Submittal No.: 05d revised: Traffic Control Plan additions revised

Description: Proposal/Contract Number: Windsor-Hartford IM BPNT (13)
Letting Date: 10/09/15; Award Date: 11/02/15
Project Description: Bridge Painting of Eleven Bridges
In the Towns of Windsor & Hartford, Windsor County, VT
Contract Amount: \$8,671,323.00; Completion Date: 10/12/18

RE:IM BPNT(13) Winsdor 42N/S, 41C – Traffic Control Plan Addendum - Resubmittal

STANDARD
T-11
MODIFIED

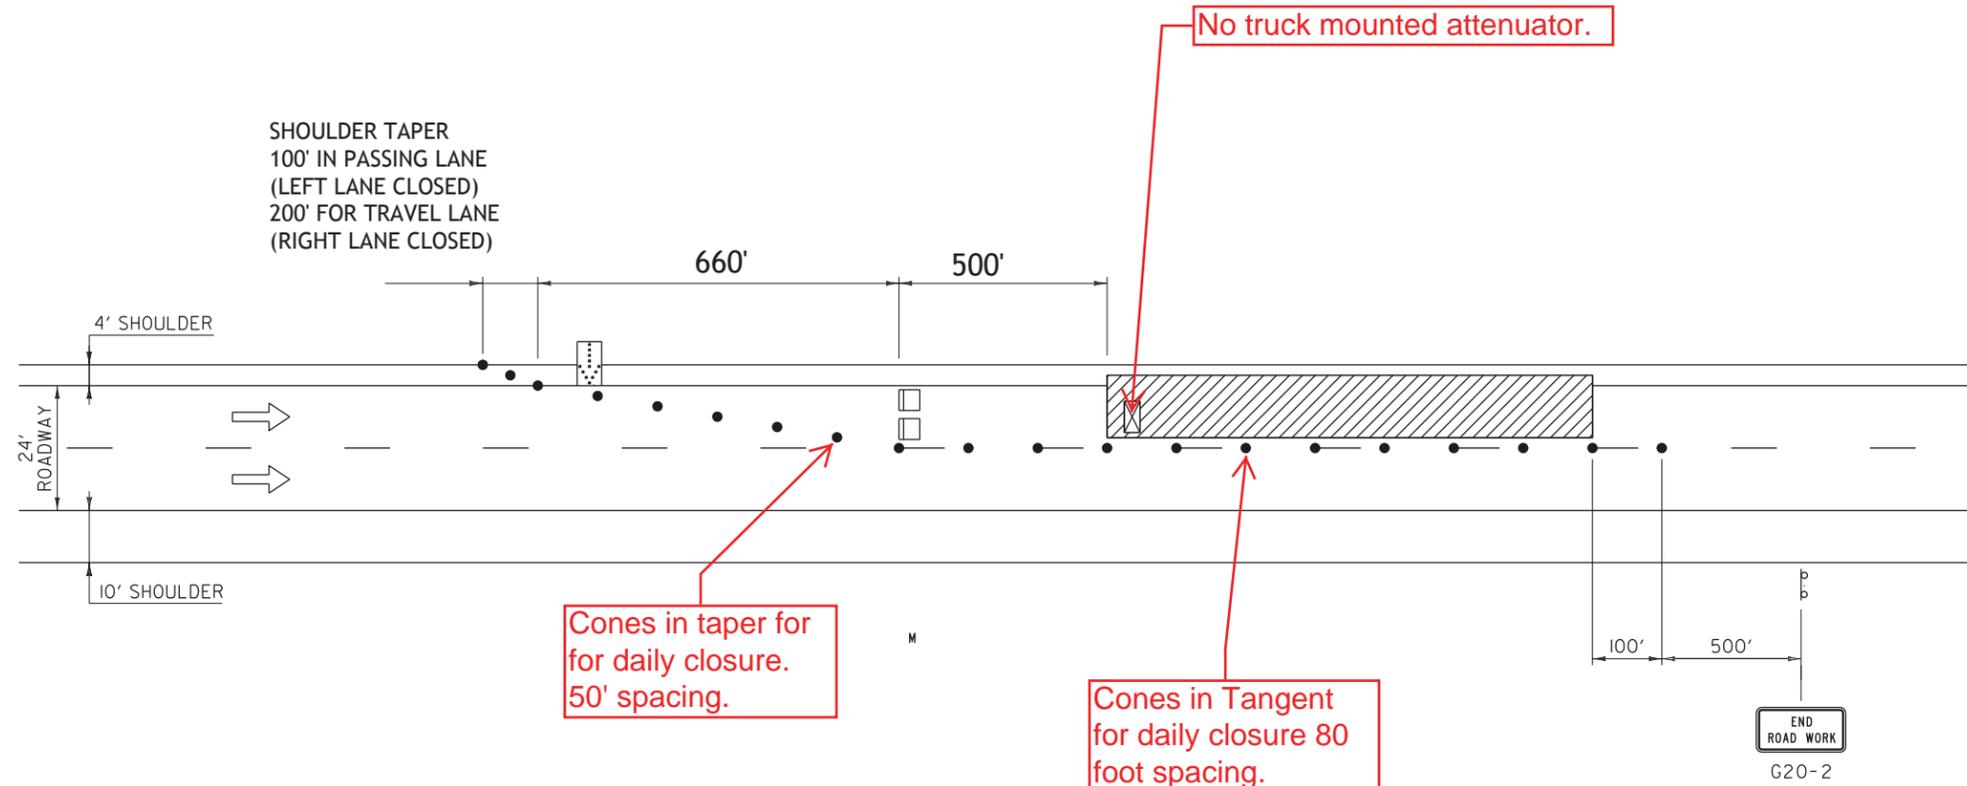
Note: Numbering Sequence based on PDF pages with submittal cover.
Sheet T-11 Temporary Lane Closure (Page 3).

1. Removed misc. 500' dimension.
2. The minimum shoulder taper for 55MPH is 185' not 220'. The adjacent 12' lane is not used for the calculation. The width of the shoulder is used for the calculation. See table in T-12 and Plans to confirm. 200' is conservative and adequate. No change.

STANDARD
T-12
Modified

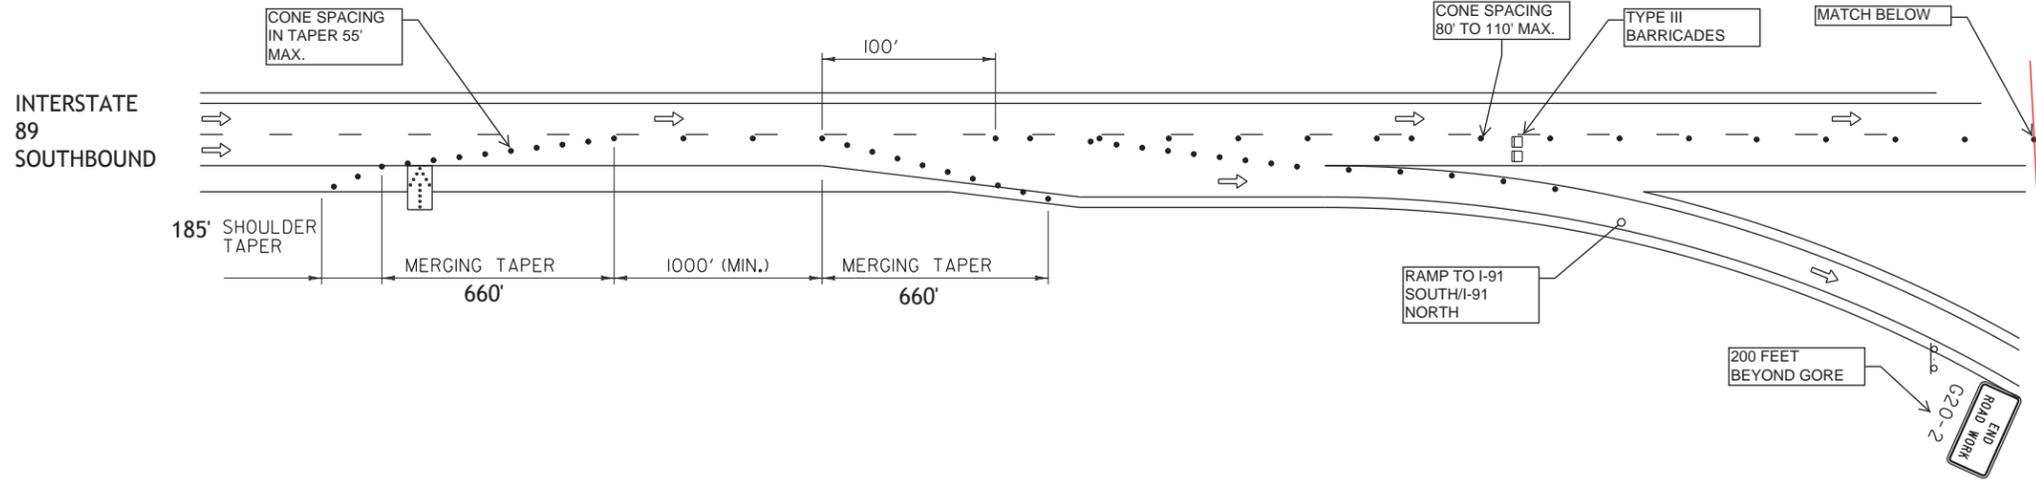
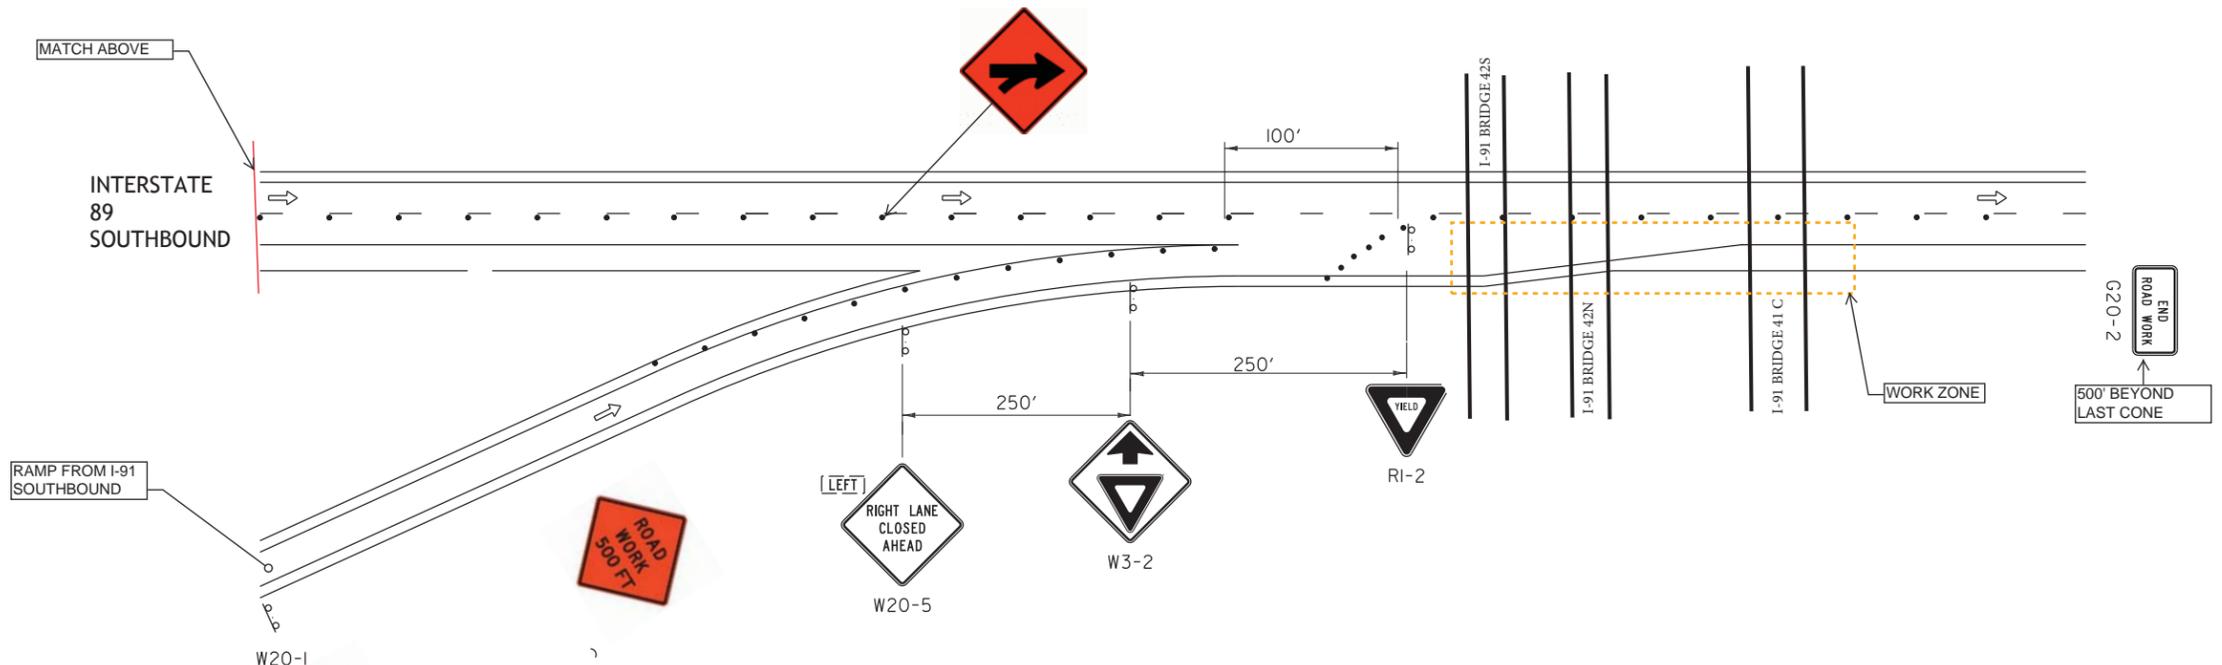
Sheet T-12 Temporary Lane Closure (Page 4)

1. Not changed to 220'. See comments previous.
2. The table for cone spacing is a maximum spacing requirement. Cones can be spaced closer. No Change.

T-23
 MODIFIED

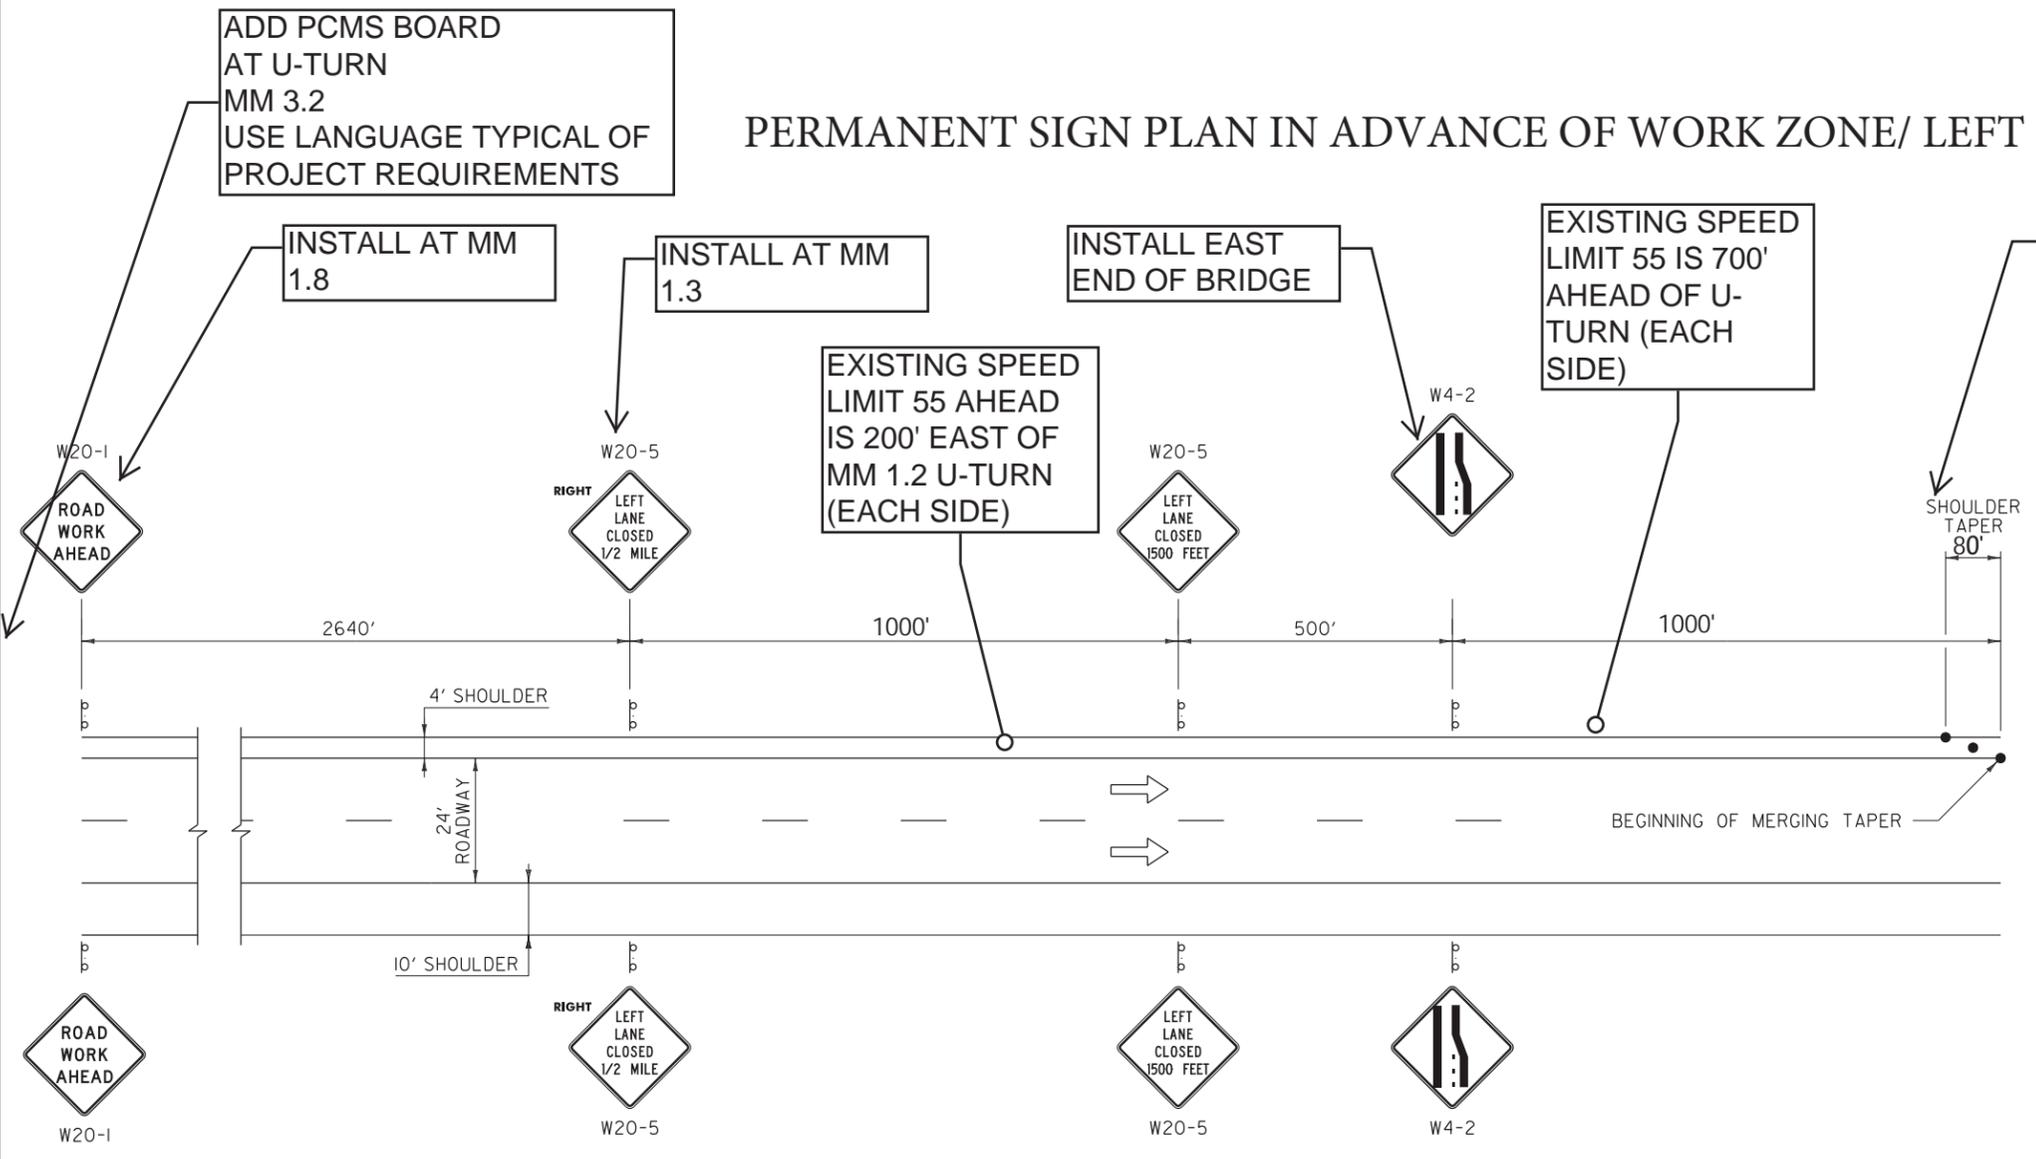
Sheet T-23 (page 5)

1. Shoulder taper not changed. See comments previous.
2. There is no space for additional acceleration for the ramp traffic.
3. Notes expanded to include the flagger sign 500' in advance of the flagger.
4. Added note requesting UTO. UTO more appropriate for thru traffic on I-89 S?
5. Added note for additional PCMS Board on I-91. South side of U-Turn MM 70.5.

1. CONES ON TANGENTS WILL BE SPACED PER SHEET T-12.
2. STANDARD T-11 WILL BE USED IN ADVANCE OF ALL CLOSURES.
3. A FLAGGER MAY BE USED AT THE RAMP ENTRANCE IF YIELDING IS DETERMINED UNACCEPTABLE. "BE PREPARED TO STOP" AND "FLAGGER AHEAD" WILL BE ADDED IN 500 FOOT INCREMENTS ON THE RAMP. THERE IS APPROXIMATELY 1500' FROM THE I-91 EXIT TO THE YIELD LOCATION WHICH WILL REQUIRE SIGNS TO BE ADJUSTED TO FIT THE SPACE. THE ADVISORY RAMP SPEED IS 30MPH. A UTO WILL BE USED ON I-89 UPSTREAM OF THE ON RAMP POSITIONED IN A MANNER THAT WILL NOT OBSTRUCT SIGNS OR SIGHT DISTANCE FOR TRAFFIC ENTERING I-89.
4. A PCMS BOARD WILL BE ADDED ON THE SOUTH SIDE OF THE U-TURN AT MM 70.5 ON I-91.

STANDARD T-13 MODIFIED

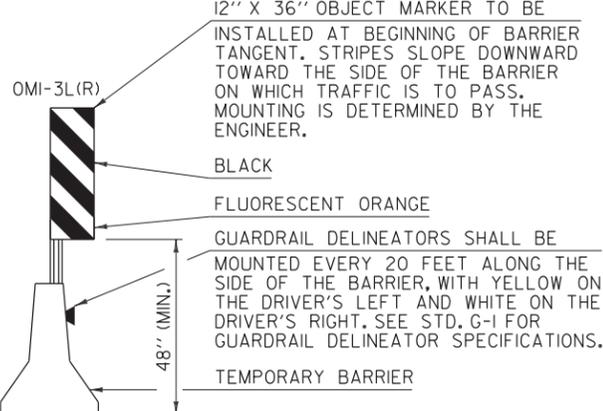
Sheet T-13 (page7)

1. Barrier not proposed to extend beyond clear zone. Guardrail is also present. No plan to make a positive connection to guardrail either. Attenuators will be used.

The work zone is for stationary
equipment required for the work above
on the bridges. The northbound traffic
is protected by existing guardrail for any
encroachment into the clear zone.

SITE PLAN FOR ROLLING ROADBLOCK ON I-89 SOUTHBOUND

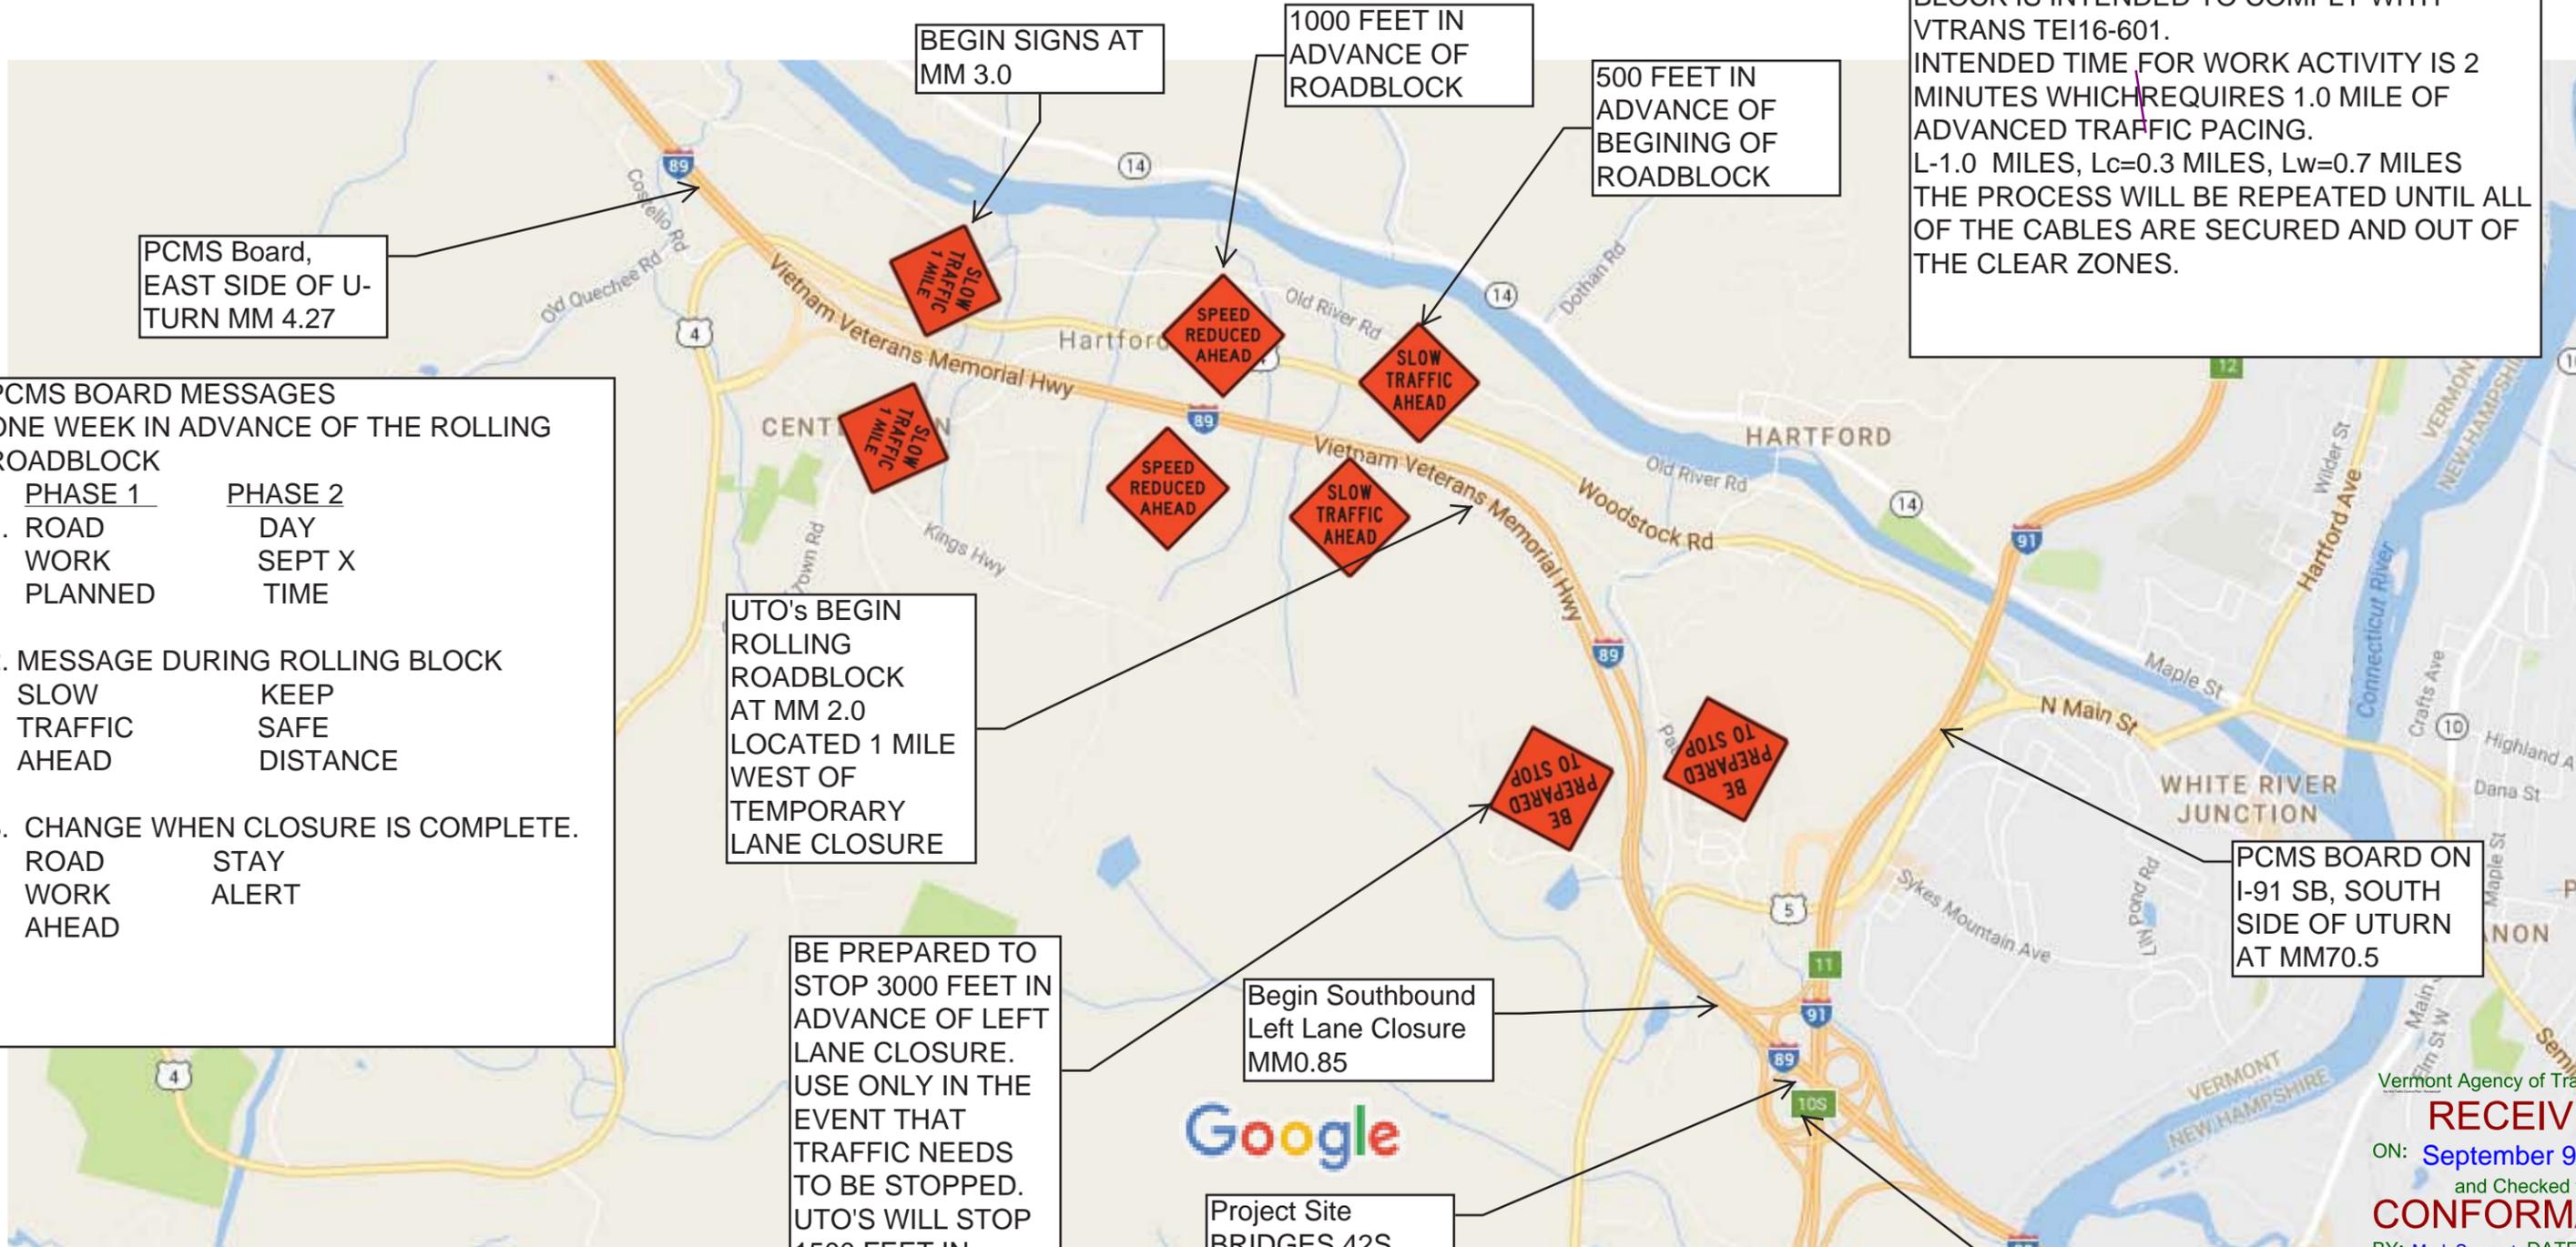
Also I have added the “be prepared to stop” signs in advance of the work if a full stop is needed. I have also added the PCMS Board on I-91S.

BE PREPARED TO STOP 3000 FEET IN ADVANCE OF LEFT LANE CLOSURE. USE ONLY IN THE EVENT THAT TRAFFIC NEEDS TO BE STOPPED. UTO'S WILL STOP 1500 FEET IN ADVANCE OF WORK IF NEEDED. STOPPED TRAFFIC MUST BE RELEASED WITHIN 10 MINUTES

RAMP FROM I-91 SB TO INCLUDE BE PREPARED TO STOP AND FLAGGER AHEAD USED AT 500 FOOT INCREMENTS ON RAMP IN ADVANCE OF STOP. TRAFFIC TO STOP WHEN LAST CAR PASSES THE WORK ZONE FROM THE ROLLING ROADBLOCK. TRAFFIC WILL BE RELEASED WHEN THE UTO AND THRU TRAFFIC PASS. THIS WORK WILL BE DONE DURING LOW VOLUME PERIODS SO TRAFFIC DOES NOT BACK UP ONTO I-91.
